Project	IEEE 802.16 Broadband Wireless Access Working Group < http://ieee802.org/16 >	
Title	Clarification on the Key Hierarchy for the PKMv2	
Data Submitted	2005-06-08	
Source(s)	Seokheon Cho Sungcheol Chang Chulsik Yoon	Voice: +82-42-860-5524 Fax: +82-42-861-1966 chosh@etri.re.kr
	ETRI 161, Gajeong-dong, Yuseong-Gu, Daejeon, 305-350, Korea	
Re:	IEEE P802.16e/D8	
Abstract	<p>Both an MS and the BS can share the PAK from the RSA-based authorization and the PMK from the EAP-based authorization in the PKMv2. Two keys, the PAK and the PMK, are used to derive the AK. The PAK is used as input data, however, the PMK is used as input key. Since the PAK and the PMK are root keys to derive the AK, both of them should be used as not input data but input keys.</p> <p>This contribution provides key hierarchy for the PKMv2.</p>	
Purpose	Adoption of proposed changes into P802.16e/D8	
Notice	This document has been prepared to assist IEEE 802.16. It is offered as a basis for discussion and is not binding on the contributing individual(s) or organization(s). The material in this document is subject to change in form and content after further study. The contributor(s) reserve(s) the right to add, ame

Figure 131-AK with the only PAK (from RSA-based ~~only~~ authorization process)

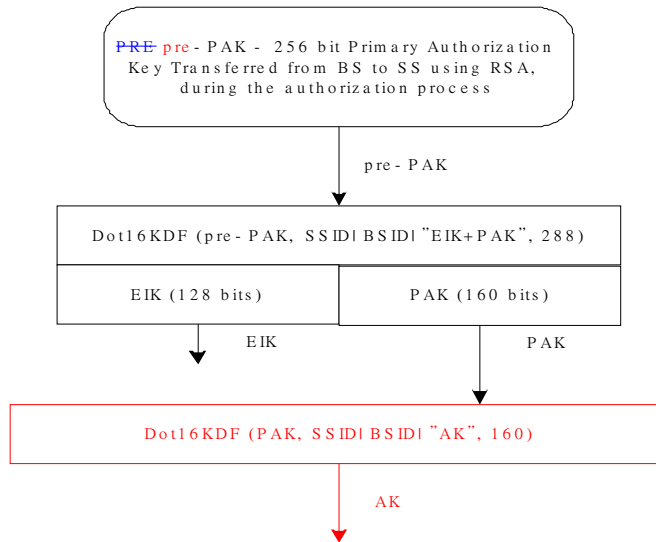
Figure 131 outlines the process to calculate the AK when the RSA-based authorization process has taken place, but where the EAP-based authentication process hasn't taken place, or the EAP method protocol used has not yielded an AAA-key:

Figure 132-AK with PAK and PMK

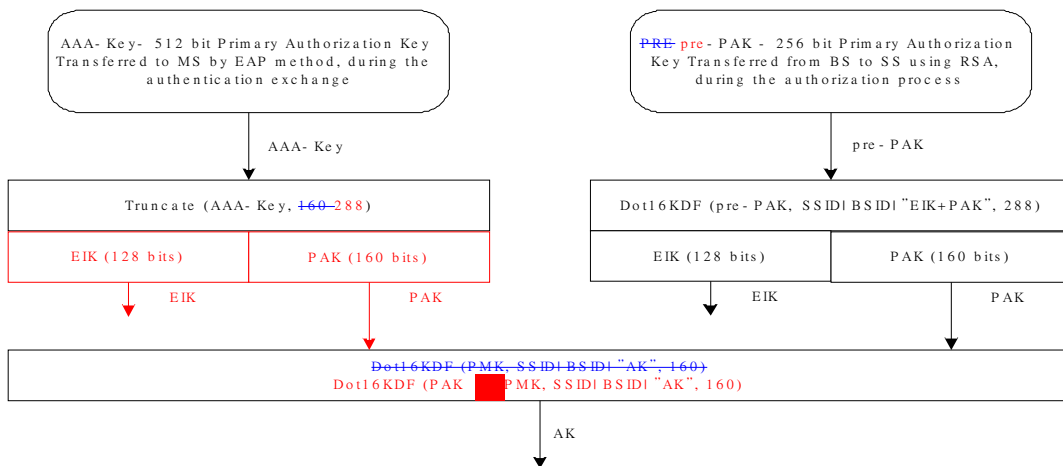
The input keys for generating the AK should be both PAK and PMK. The exclusive-or (XOR:) value of PAK and PMK as input key is used to derive the AK. The generation method of the AK is proposed as follows.

Figure 132 outlines the process to calculate the AK when both the RSA-based authorization exchange has taken place, yielding a PAK and the EAP based authentication exchange has taken place, yielding an AAA-key:

Figure 133-AK with the only PMK (from EAP-based ~~only authentication~~ authorization process)

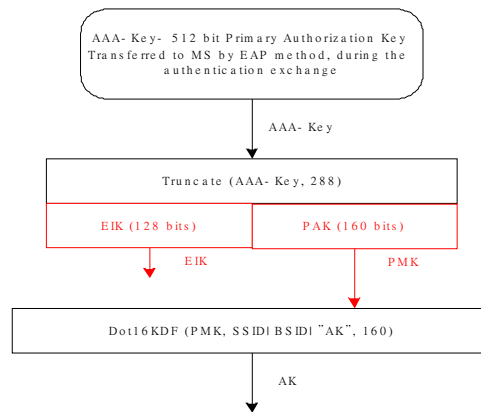
Figure 133 outlines the process to calculate the AK when only the EAP based authentication exchange has taken place, yielding an AAA-key:
